NUCLEAR REGULATORY COMMISSION

Title: Advisory Committee on Reactor Safeguards Subcommittee on Fermi Unit 3

Date: Thursday, August 16, 2012

Meteorological Tower Location

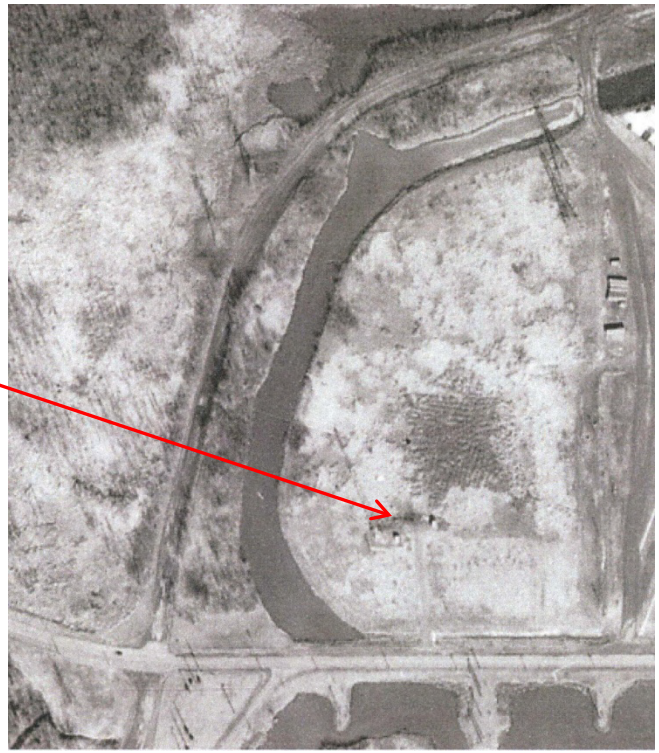
MEMBER SCHULTZ: Peter, I take it that these two data sets were used for updating FERMI 2 analyses. Is that true? Well, let me finish the question. If so, what difference did one see between the two sets of data?

I understand that they're within the DCD site parameter values. But that is bounding. But with regard to those two sets of data, what difference did you see? It goes back to the question about the trees and so forth.

So what we did was we put them side by side. And for every release receptor pair, for every time period, so two through the eighth we picked the most limiting higher of two, and used that as the final answer for the other evaluations that were done downstream.

In response to these concerns, the applicant provided the staff a copy of the 1985 through 1989 onsite meteorological database and stated that the aerial photographs of this site, the area surrounding the Fermi 3 meteorological tower confirmed the absence of significant air flow obstructions to wind measurements during this earlier time period.
